# CATAWBA COUNTY BLACKBURN RESOURCE RECOVERY FACILITY TREATMENT AND PROCESSING FACILITY CONSTRUCTION DRAWINGS

**MAY 2025**  
**REV. JUNE 6, 2025**  
**REV. JULY 15, 2025**  
**REV. AUG. 5, 2025**

CONSTRUCTION DRAWINGS

**SHEET  
 4**

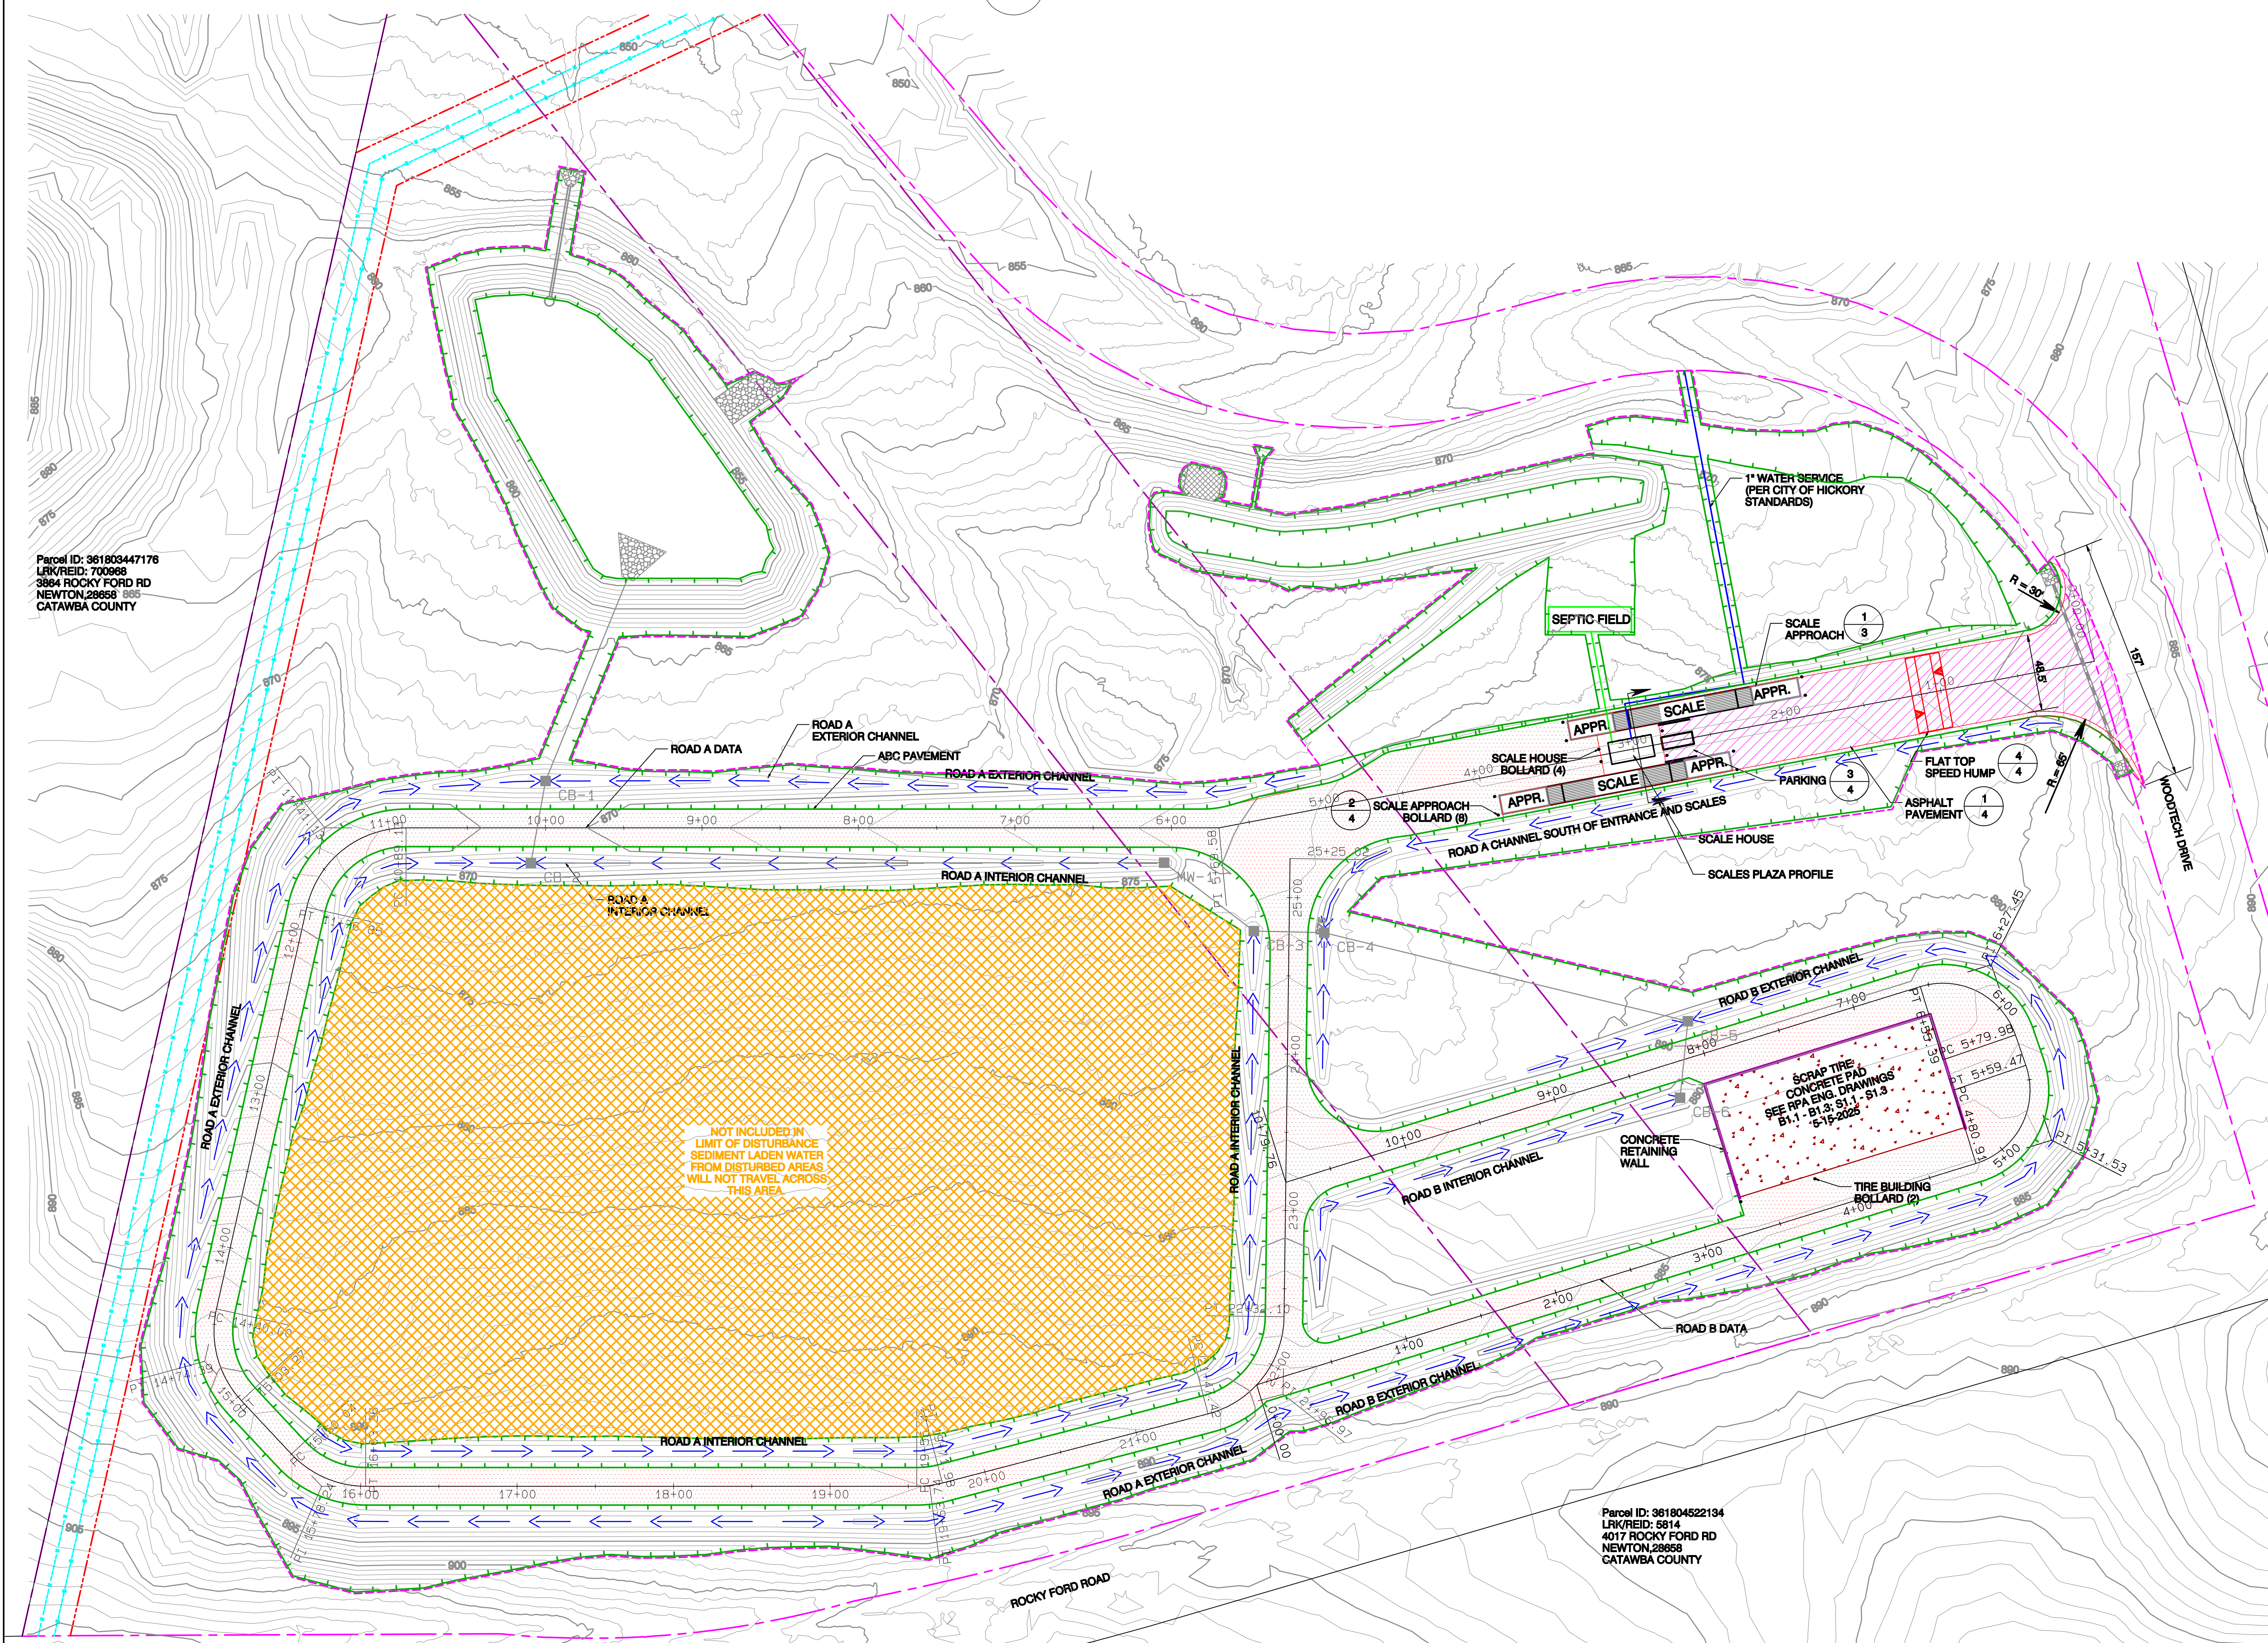
- APPENDIX 2 NOTES**
1. DETAIL 3, SIDEWALK DIMENSIONS CORRECTED.
  2. LANDSCAPE BUFFER TO BE PERFORMED BY OWNER, NOT IN THIS CONTRACT.
- REVISED JULY 15, 2025
1. LIMIT OF DISTURBANCE REVISED.

**SHEET 8**

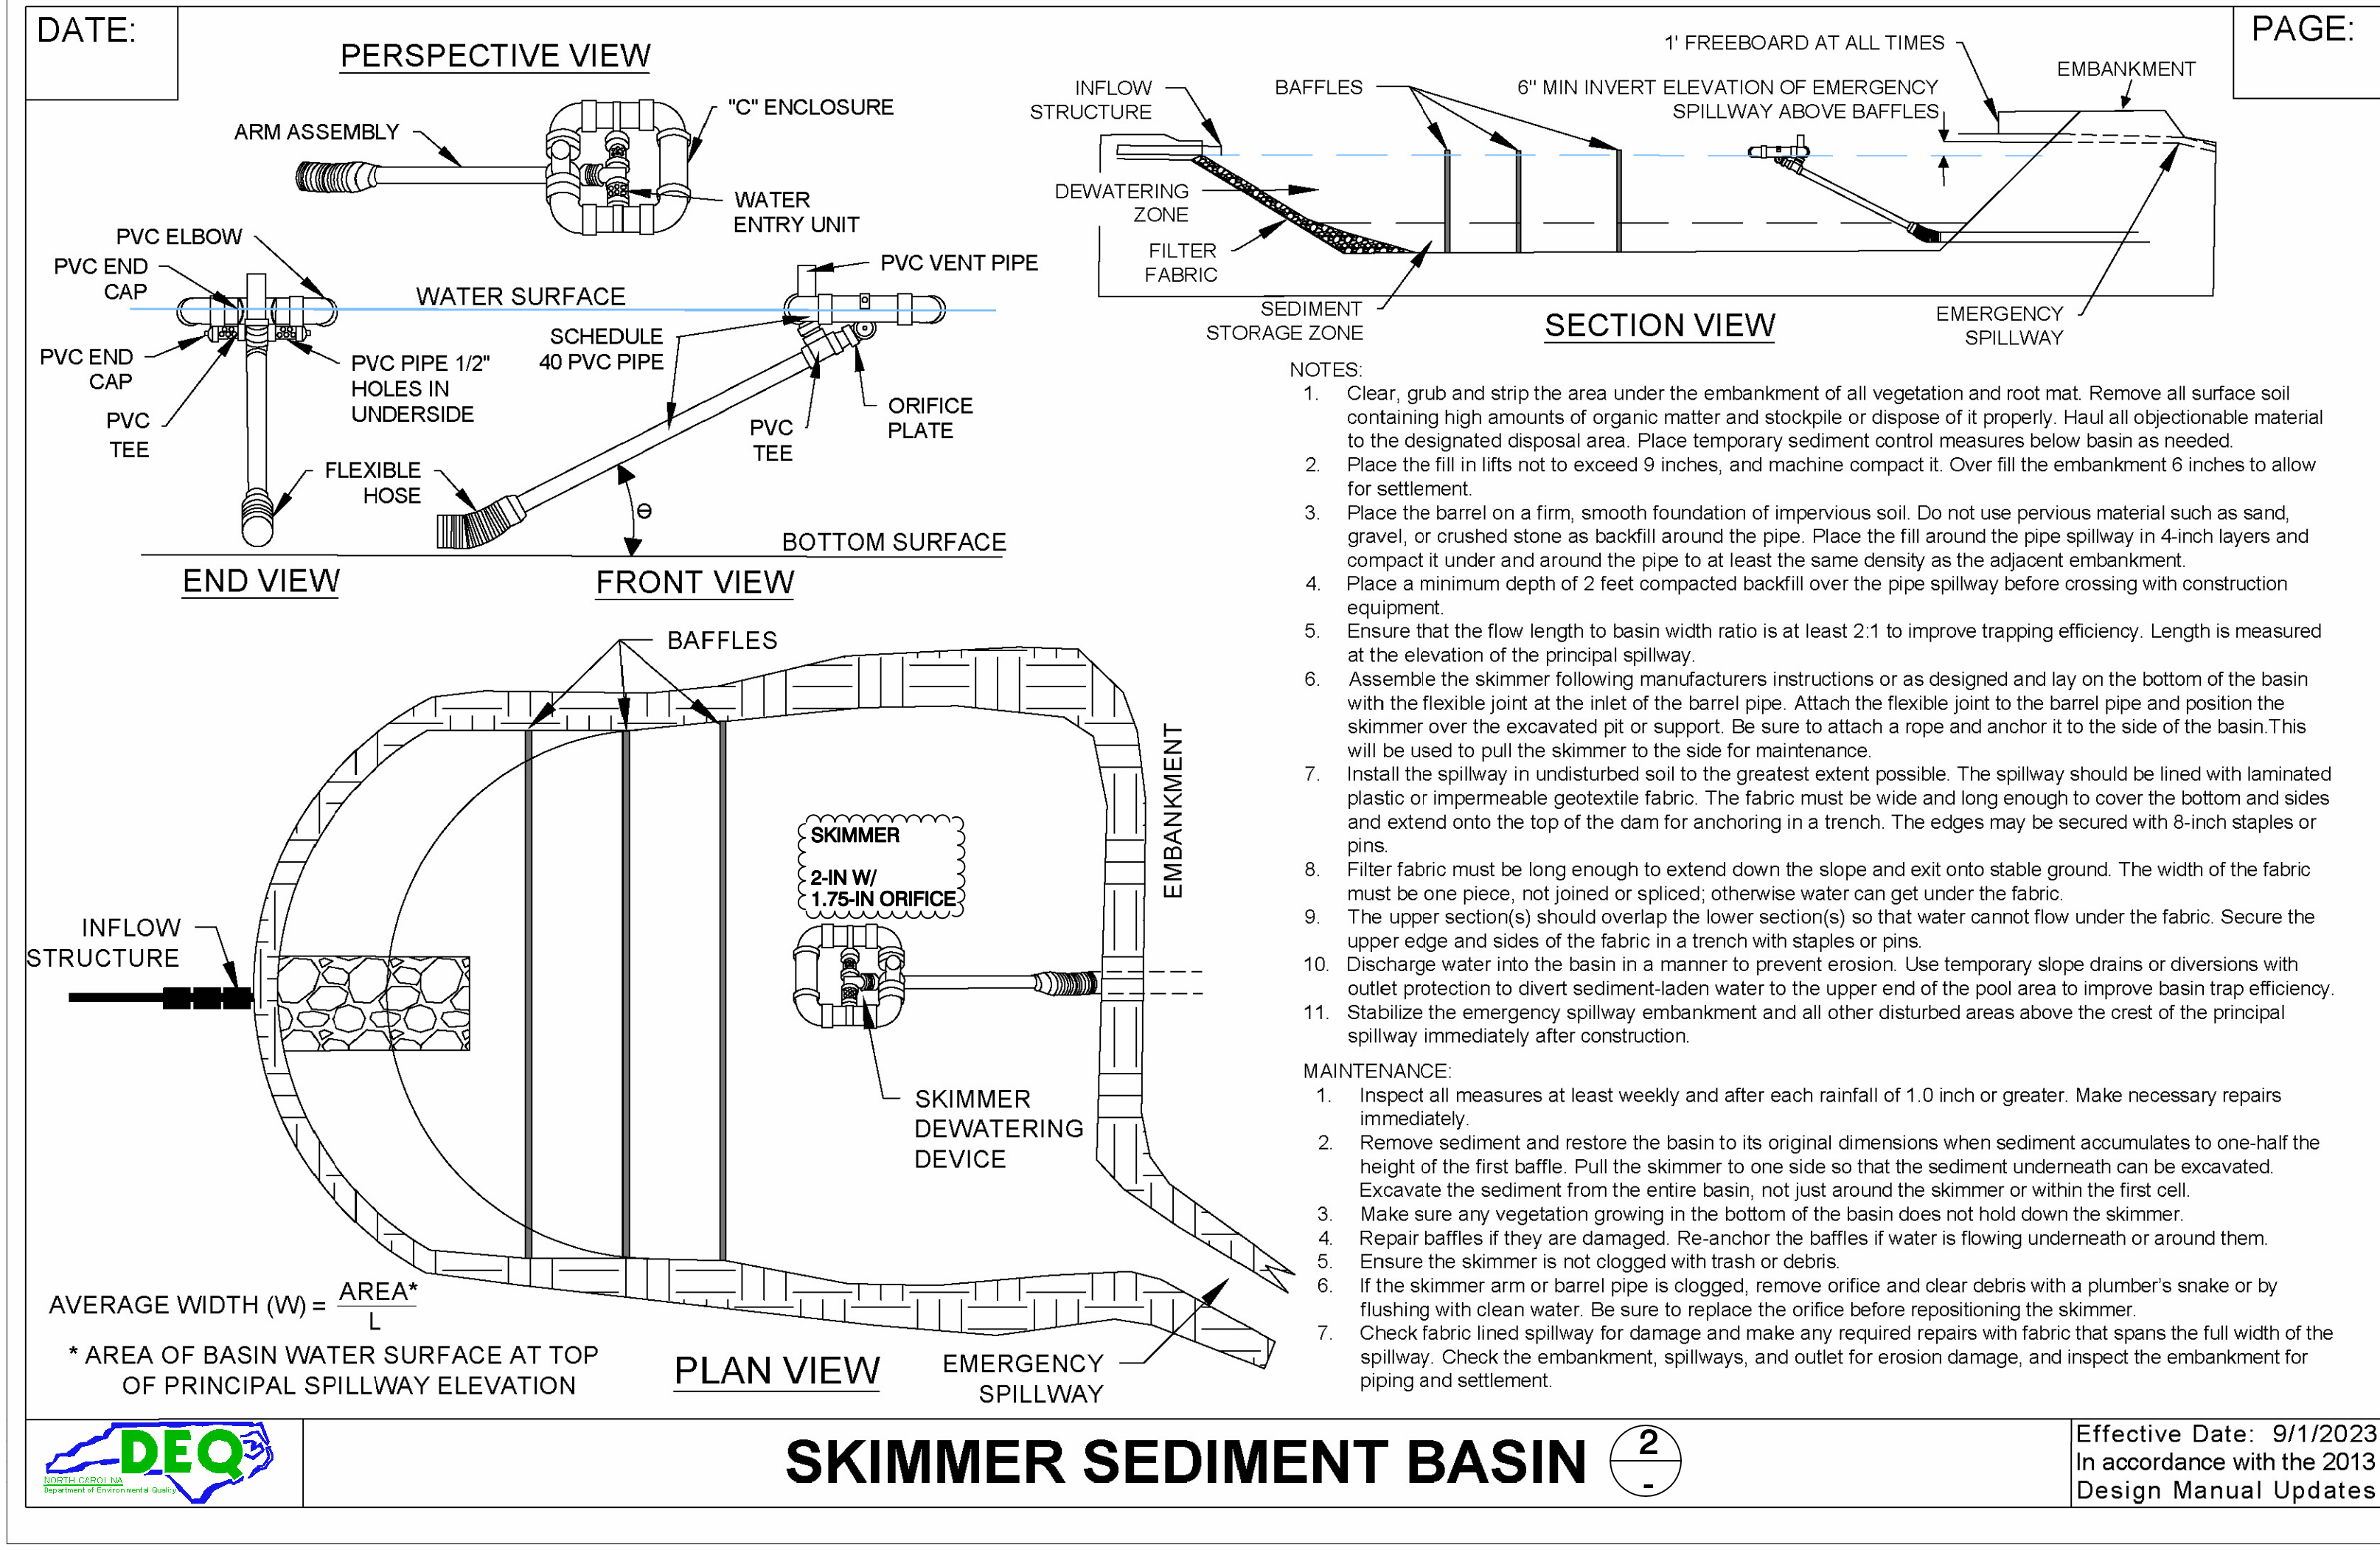
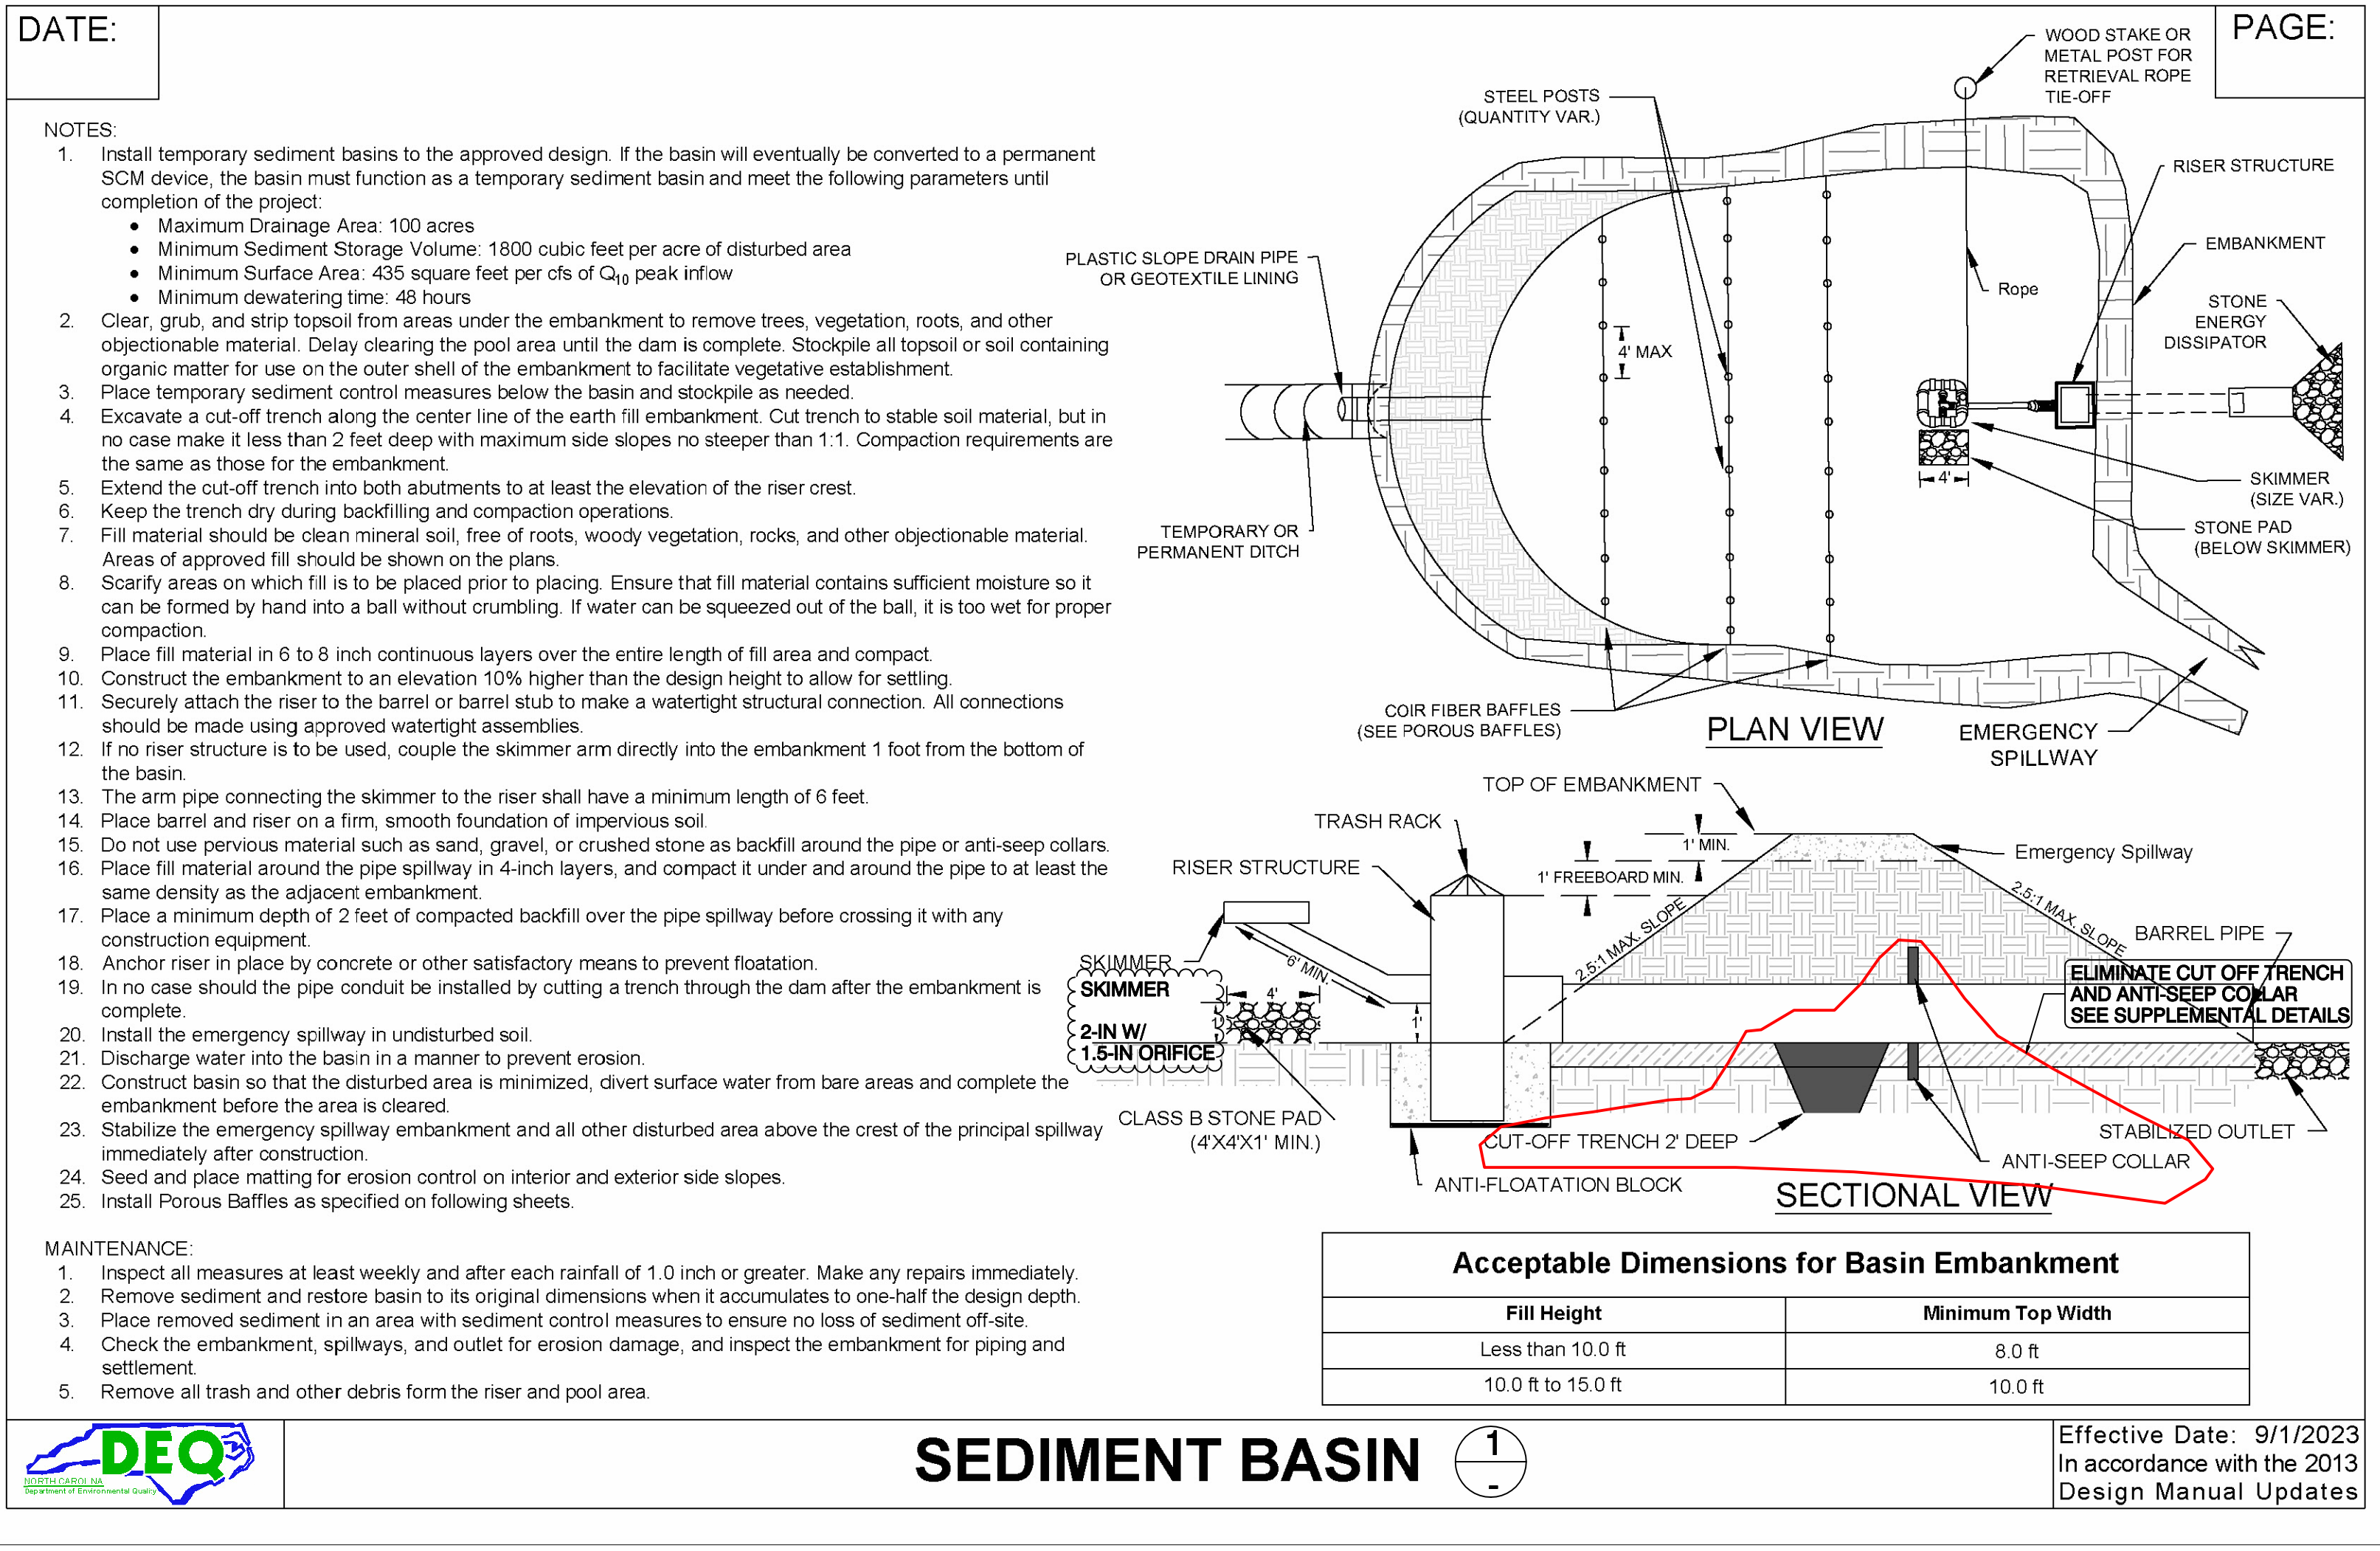
REVISED JULY 15, 2025  
1. REVISED SKIMMER SIZE ON DETAIL 1 AND DETAIL 2  
2. SEDIMENT POND 1 ELEVATION TABLE CORRECTED.  
3. SEDIMENT POND 1 RIPRAP ADDED TO EMERGENCY SPILLWAY
